YGI / NMED Modeling questions: 11/17/2026

From Rathod, Sagar, ENV <sagar.rathod@env.nm.gov>
Date Tue 11/17/2026 1:41 PM
To John Ke <jke@trinityconsultants.com>; RLiles@trinityconsultants.com <RLiles@trinityconsultants.com>
Cc Mustafa, Sufi A., ENV <sufi.mustafa@env.nm.gov>

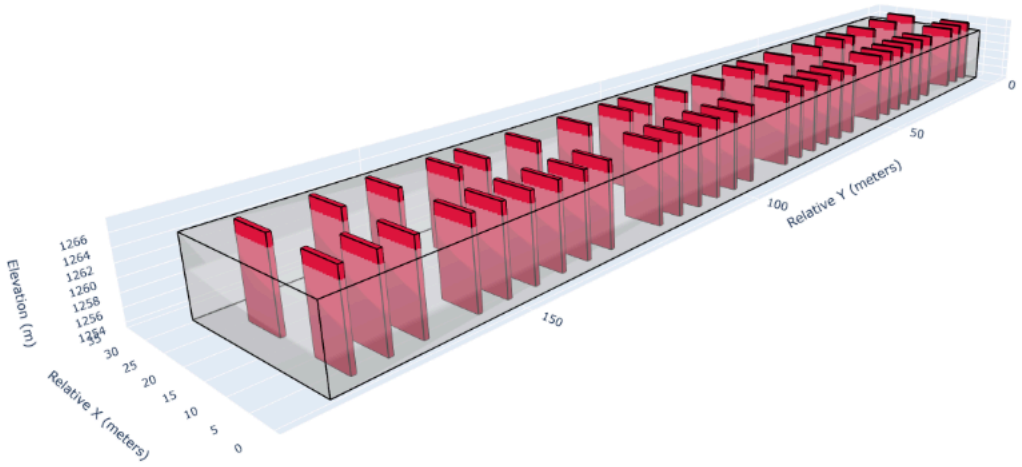
2. Plenum Dimensions: Please confirm whether 23.22 ft x 2.25 ft represents the internal dimensions of the plenum.
3. AERMOD Building Representation: Please confirm whether the figure below accurately represents the applicant's building modeling in AERMOD for a sample building T01. The NMED Modeling unit created this figure using the latest BPIP Input file submitted by the applicant.
